PERRY NUCLEAR POWER PLANT

March 19, 1991
PY-CEI/NRR-1316 L

Perry Nuclear Power Plant
Docket No. 50-440
Technical Specification
Change Request - ECCS Actions

This amendment requests revision of Technical Specification 3.3.3 Actions, to make the Actions for various ECCS Actuation Instrumentation consistent with the purpose and logic of the instruments involved.

Figure 1

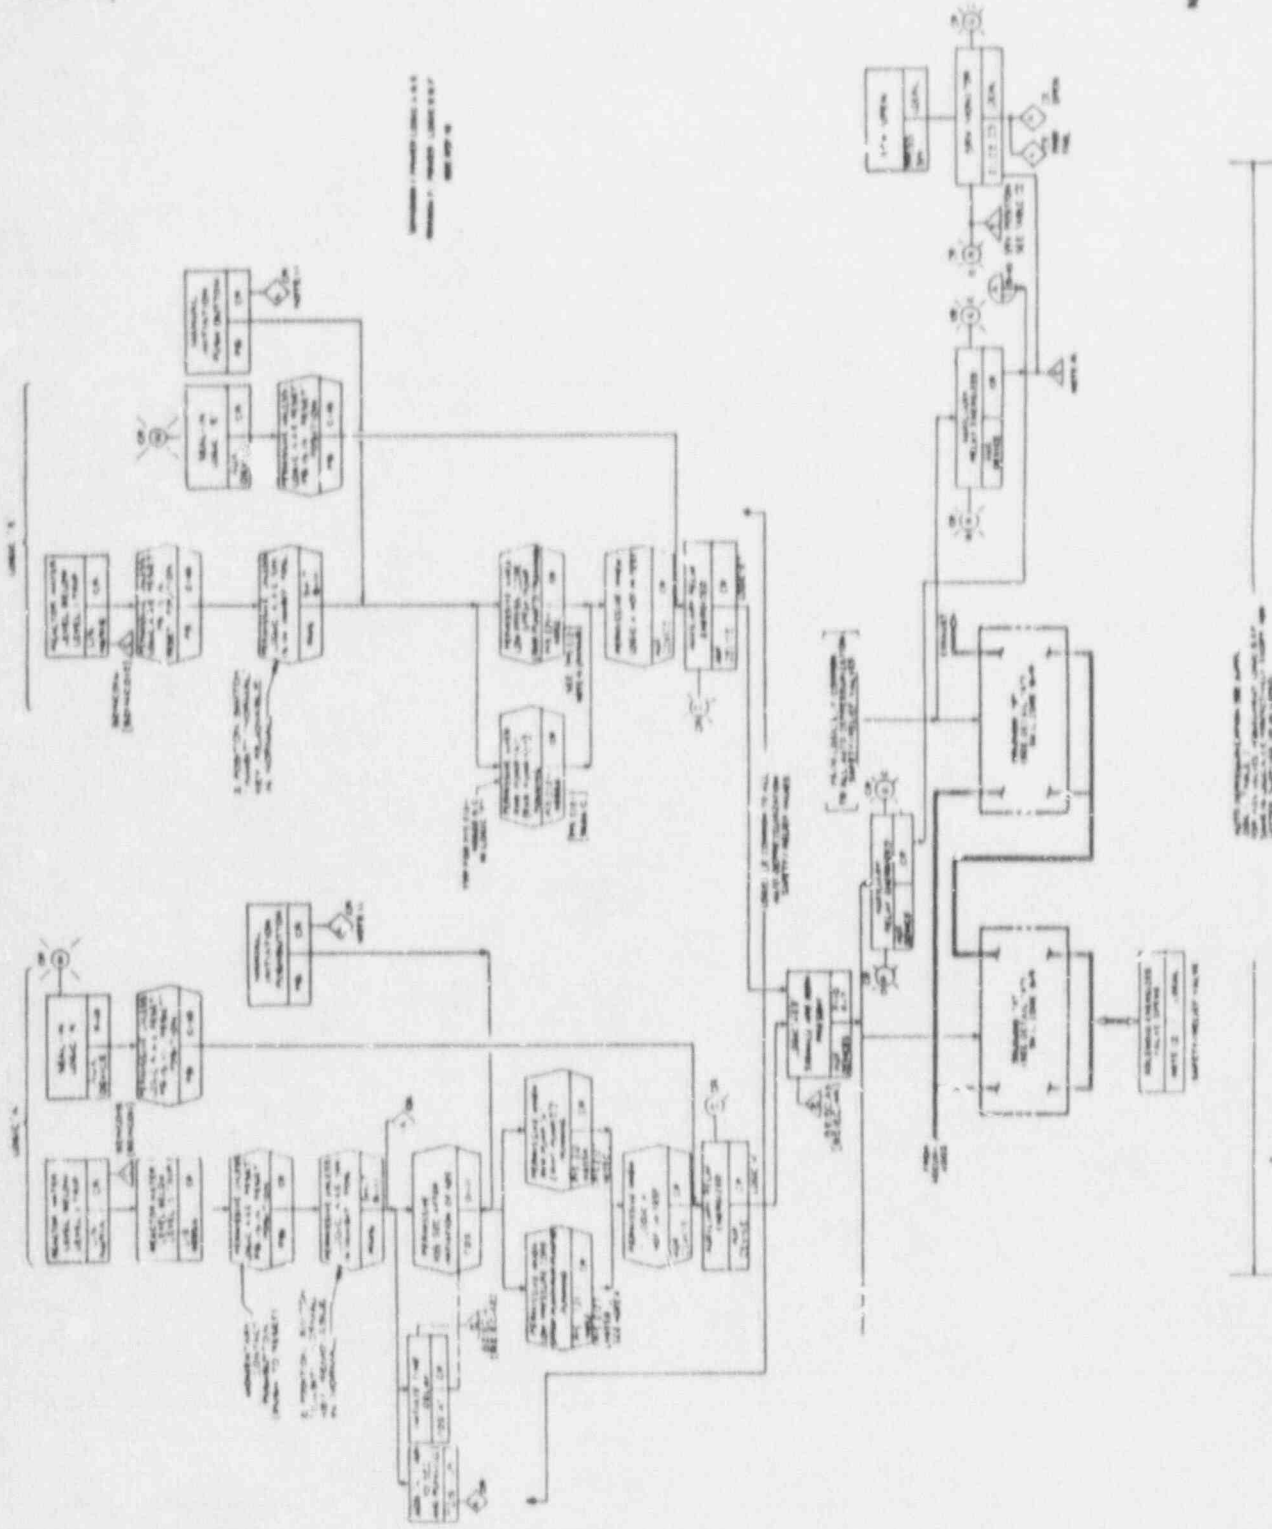
The ADS actuation system is discussed in the USAR Section 7.3.1.1.1.2 and the simplified logic for one trip system (Division 1) is depicted on USAR Figure 7.3.3, Sheet 6 of 7. Figure 1 of this letter is a reproduction of the applicable parts of the USAR Figure. In addition, Figure 2 provides another depiction of the Division 1 and 2 ADS Trip System logics, and shows that either logic train actuation will result in all eight ADS valves opening. As shown on this logic the Manual Initiation pushbuttons form a part of the overall initiation logic for both Division 1 and Division 2. For Division 1 [and 2] the ADS logic is initiated manually when the manual initiation pushbuttons in channels A and E [B and F] are depressed and there is a low pressure ECCS system running (LPCS or LPCI A for ADS Division 1, LPCI B or C

For example, as can be seen on Figure 1 and 2 of this letter, the Reactor Vessel Water Level-Low, Level 3 instruments are vital to the automatic actuation of the ADS trip system. However, the action required when one of these channels becomes inoperable is to declare the ADS trip system inoperable (ACTION 31). This is the appropriate action since the other Division can complete the automatic ADS logic if necessary. If the trip system is declared inoperable, ACTION c.1 of Technical Specification 3.3.3 permits 72 hours or seven days (depending on the operability of the HPCS and RCIC systems) to restore the trip system to OPERABLE status.
